**City of Portland, Maine - Building or Use Permit Application** 389 Congress Street, 04101, Tel: (207) 874-8703, FAX: 874-8716

Location of Construction: <b>City Point Rd. Peaks Island</b>		Owner: <b>T. Covington Johnson</b>		Phone: <b>(207) 766-3375</b>		Permit No: <b>990586</b>	
Owner Address: <b>P.O. Box 48 Peaks Island</b>		Lessee/Buyer's Name:		Phone:		BusinessName:	
Contractor Name: <b>Owner</b>		Address:		Phone:		Permit Issued: <b>JUN 9 1999</b>	
Past Use: <b>Single Family</b>		Proposed Use: <b>Dame</b>		COST OF WORK: <b>\$ 250.00</b>		PERMIT FEE: <b>\$ 25.00</b>	
				FIRE DEPT. <input type="checkbox"/> Approved <input type="checkbox"/> Denied		INSPECTION: Use Group: <b>13</b> Type: <b>11</b>	
Proposed Project Description: <b>Amending Permit #990091 Adding 234 SQ. Feet On 2nd Floor Deck w/ 2x6 Decking.</b>				Signature:		Signature:	
				PEDESTRIAN ACTIVITIES DISTRICT (P.A.D.) Action: <input type="checkbox"/> Approved <input type="checkbox"/> Approved with Conditions <input type="checkbox"/> Denied		Zone: <b>IR-2</b> CBL: <b>087-S-009</b>

**BUILDING PERMIT REPORT**

LAND USE - ZONING REPORT

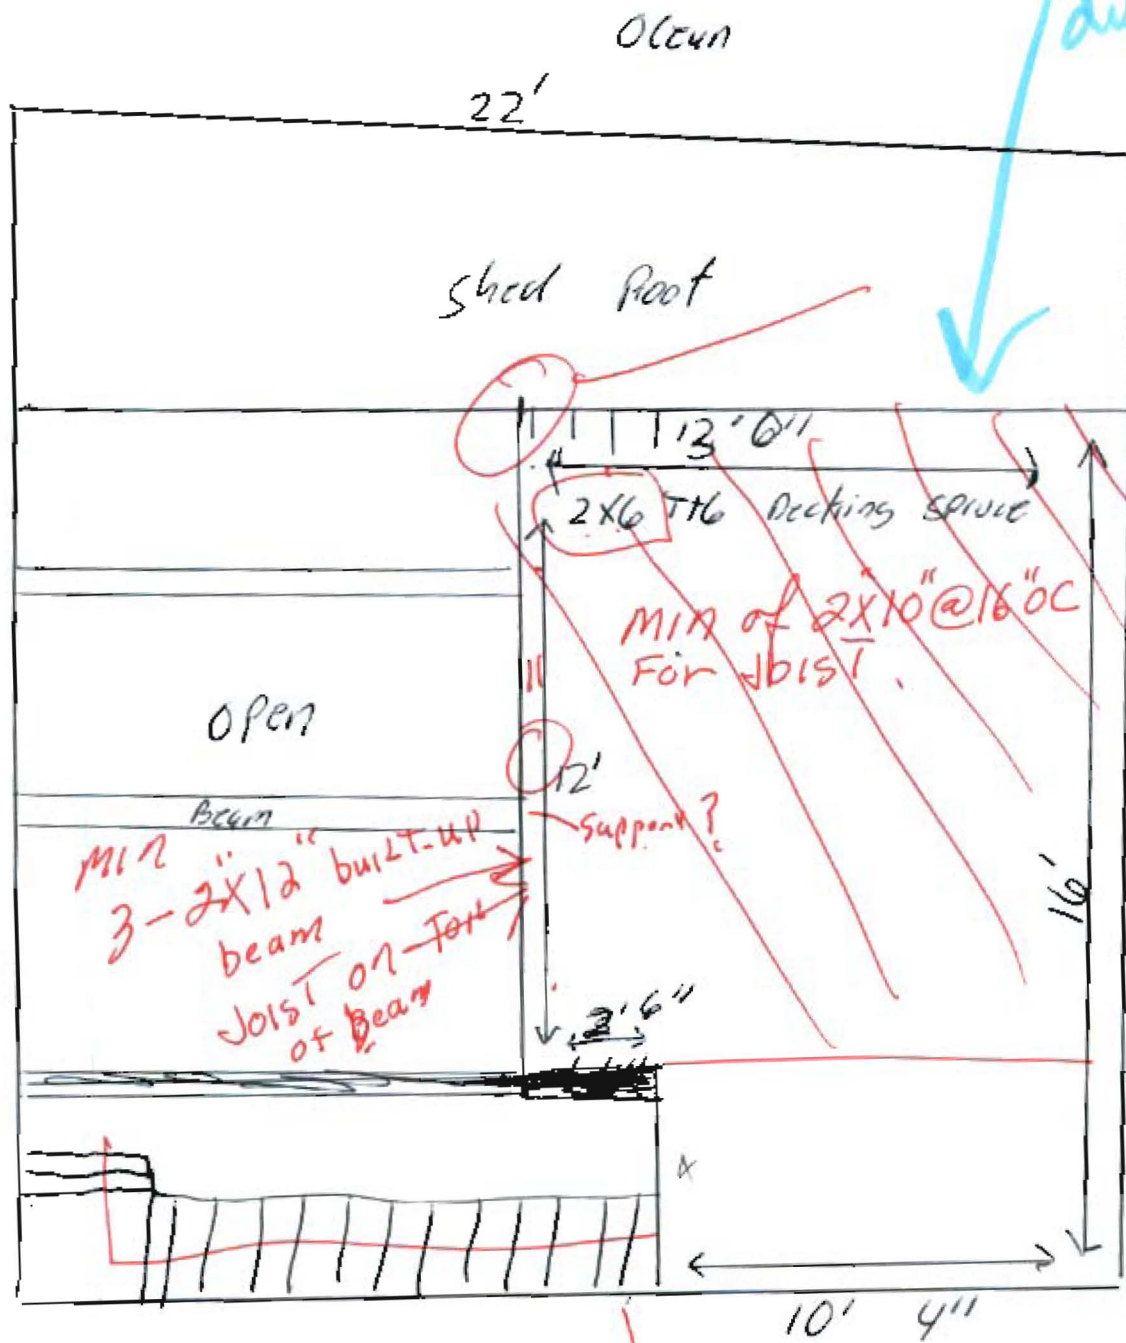
stairs 7 3/4 rise  
 36" Landing  
 10' net trends  
 6' 8" Head room

CEO - Floor Dimensions  
 Shall be NO  
 diff. than  
 given

stair not to scale

see STAIR  
 detail

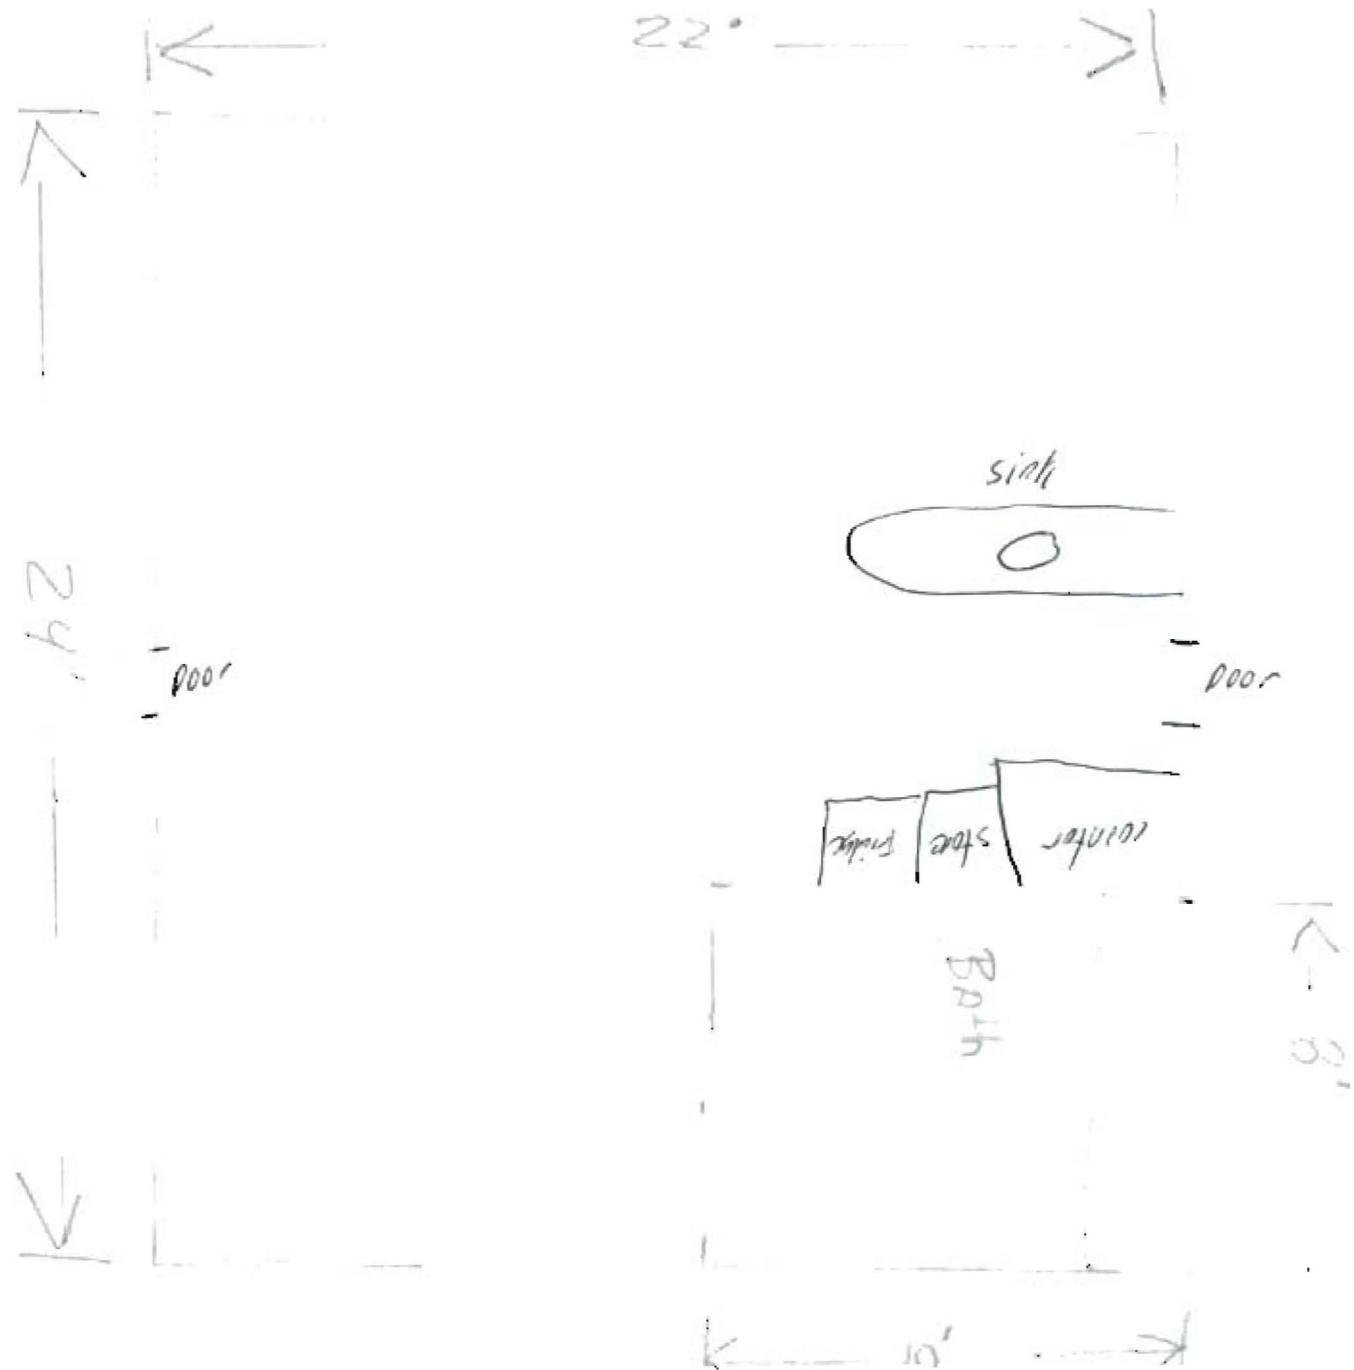
Proposed Use/Work - Amend permit # ~~07-019~~ 990091 to enlarge

Sewage Disposal - floor area (2nd floor) within the allowable 30% increase

Rear Yard is allowed up to 771.65 sq ft of floor area

Side Yard ① 1st floor main house = 16' x 22' or 352 sq ft

Projections ② Seaside Porch = 8.625' x 22' or 189.75 sq ft  
541.75 sq ft

Height - ③ proposed partial 2nd floor =

Loading Docks - ~~15' x 18'~~ 2nd floor 10.33' x 16' = 165.28

Site Plan - 2.5' x 12' = 30.00

Stairway up = 42.00  
given  
less platform on 1st floor + RA  
237.28  
- 16.00  
221.28

771.65  
- 541.75  
229.90 sq ft

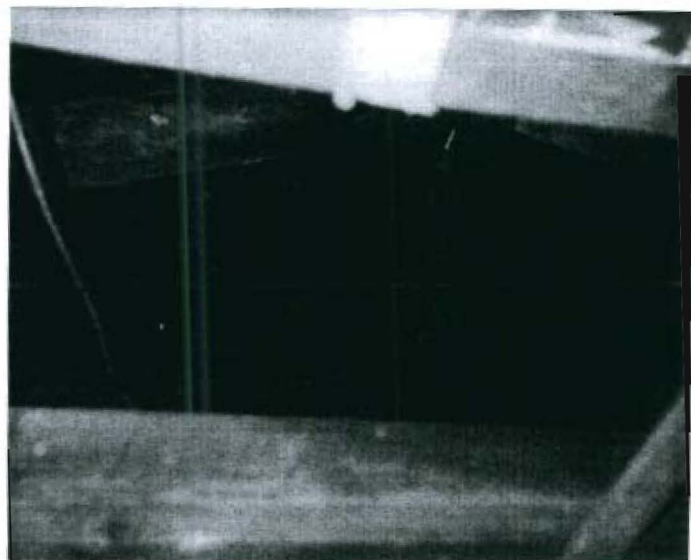
$$13 \times 12 = 156$$

$$10.25 \times 4 = 41$$

197 sq ft up stairs

stairs 42 sq ft

239 Total Add up stairs

Total allowed with 30% sq ft
